PLANNING AND LICENSING COMMITTEE

ADDITIONAL PAGES UPDATE

Submission from Albion Street Residents Group

17/04141/FUL Variation of condition to amend approved landscape scheme

Figure 1

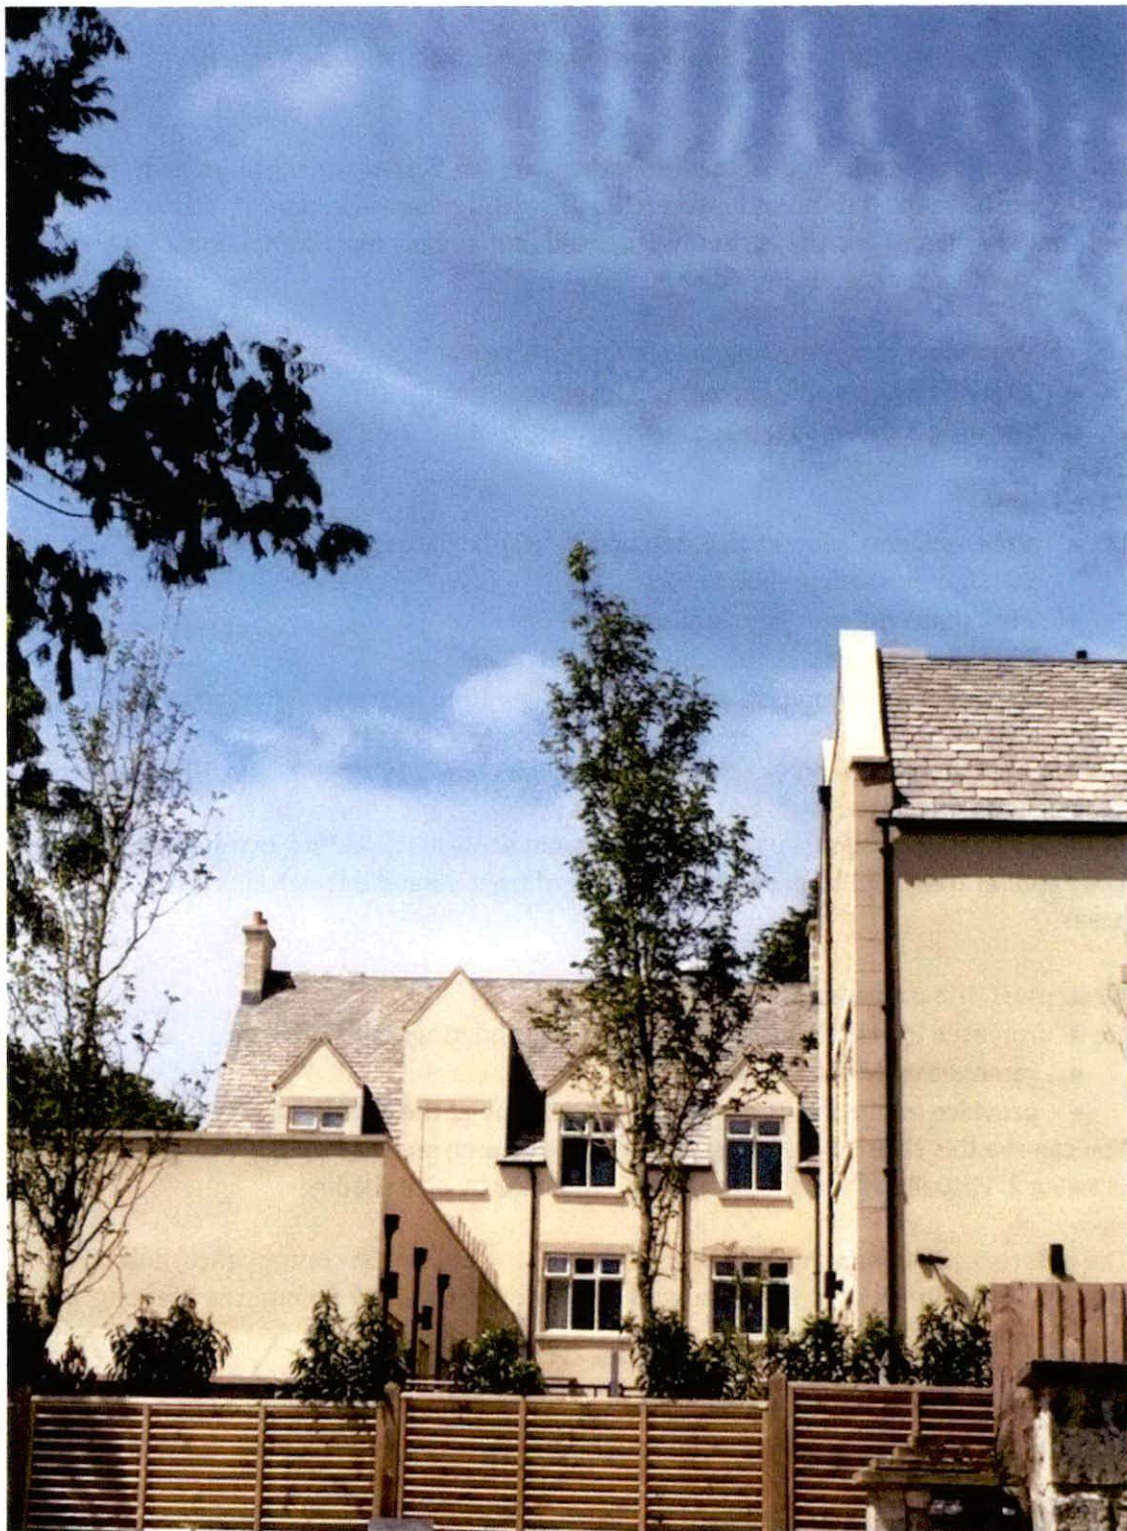
Figure 1 shows the direct view from the lane off Albion Street and demonstrates clearly that the view of the building on the development is not mitigated at all by the tree planting. The

overwhelming view is of built form and rendered elevation. The fence erected on the boundary does nothing to mitigate the overbearing effect.

In Figure 2, a slightly increased density of tree planting can be seen to the right of the photograph, which achieves a better degree of mitigation. However, the tree on the left hand side is, we understand, due for removal under the current proposals.

APPROVED

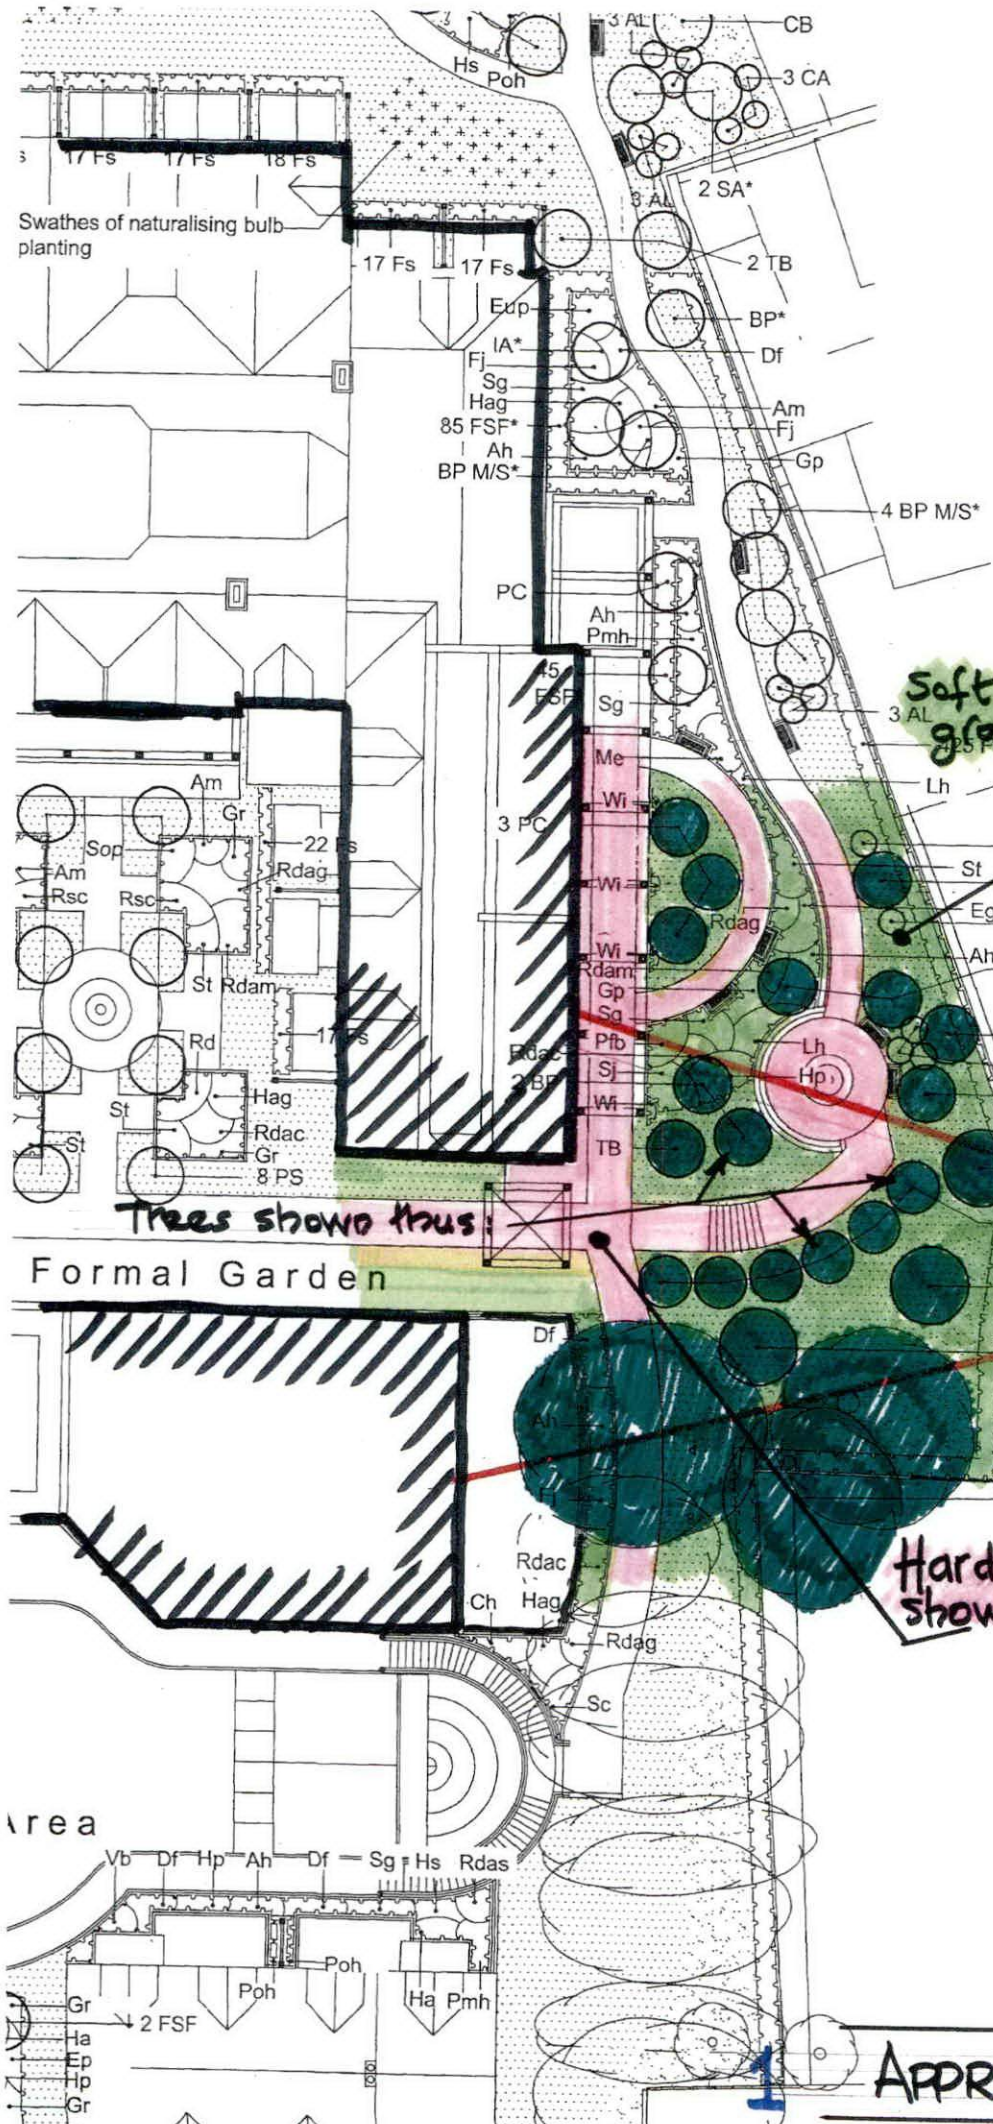
We have compared the landscaping approach when viewed from the lane off Albion street, between the original consent and the current proposal, and shown this on the attached **drawings 1 and 2**. Essentially the original consent achieved screening by retaining the two large conifer trees and by providing a number of trees spread through soft landscaped areas.

In the representative view arc shown the **Approved scheme contains 14 trees including 2 existing mature trees**, but the **Proposed scheme has just 3 trees and one failed tree**.

CENTRAL VIEW ARC FROM LAINE OFF ALBION ST (14 trees including 2 etc in this zone)

2. PROPOSED

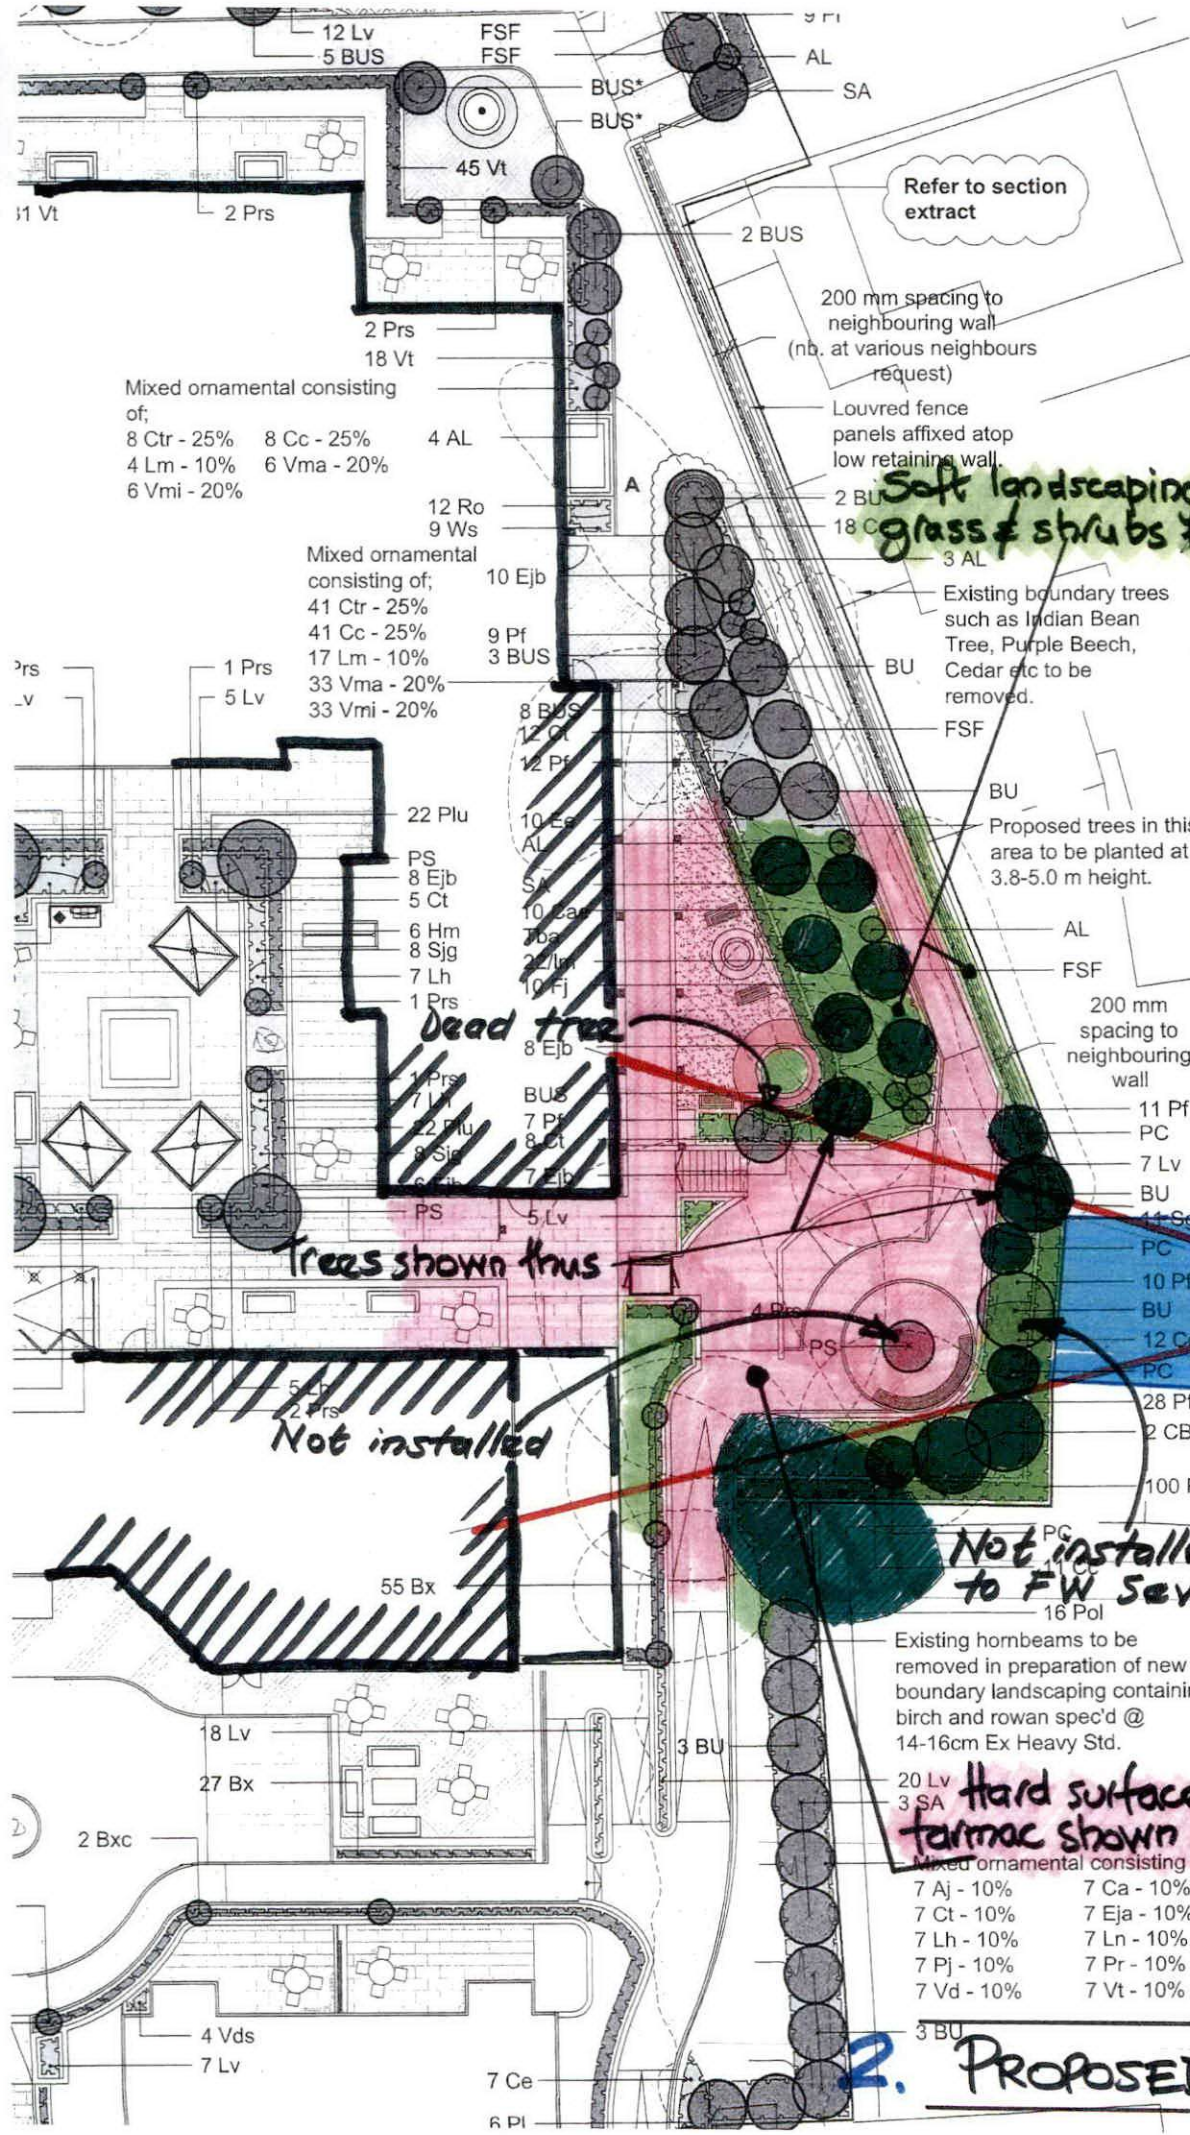
- **replaces** the soft landscaping with tarmac and other hard surfaces,
- **removes** mature trees, and
- provides **minimal** tree planting in a single line at the boundary.

You can see this clearly by contrasting the area of green and pink on the two drawings: on drawing 2, virtually all the green shading is replaced by pink shading.

In addition one of the planted trees has evidently not survived as there is inadequate space around it, a further tree shown on the approved plan has not been installed, and at least one further tree cannot be planted in the perimeter strip as it would sit over the Foul Sewer that exits the site into the lane.

Clearly this is the case as the foul water sewer prevents completion of this screen, and per your landscape Officer’s recommendation, additional planting is required. As you can see from drawing 2, this has not been provided for in the proposed scheme.

CENTRAL VIE W ARC FROM LANE OFF ACBION ST. (3 trees & 1 dead tree in this zone)

Dead tree

Not installed

Not installed - due to FW sewer

3. PROPOSED

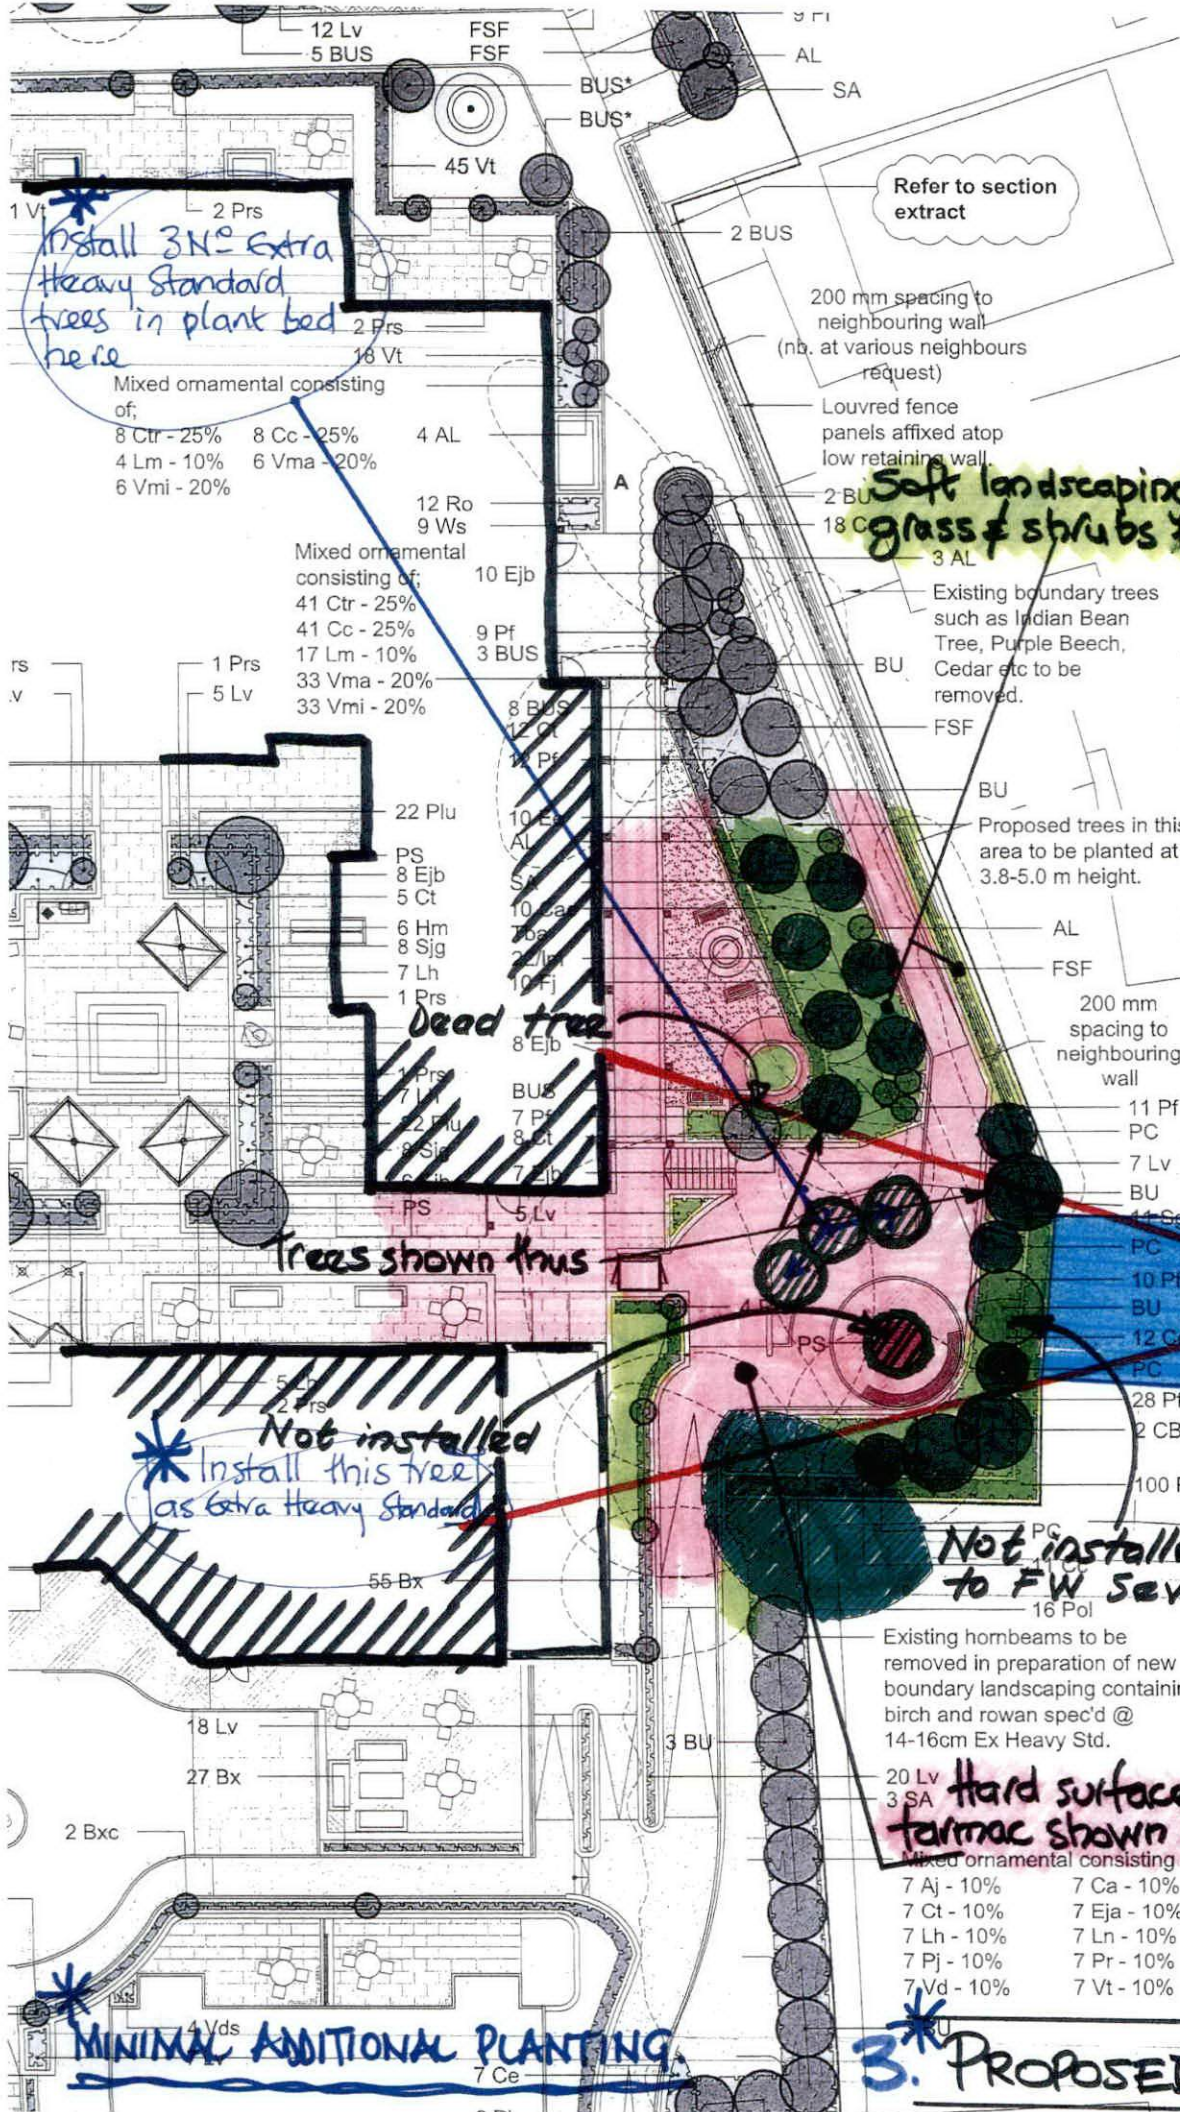
We have again shown some additional tree planting that could be achieved on our further attached **drawing 3**.

Together with the actual planting of the further omitted tree in this area as a large specimen, we earnestly hope that you will insist that this minimal amount of additional planting is done. Otherwise, this scheme clearly cannot be acceptable.

*** Install 3 No Extra Heavy Standard trees in plant bed here**

*** Not installed
Install this tree as extra Heavy Standard**

MINIMAL ADDITIONAL PLANTING.
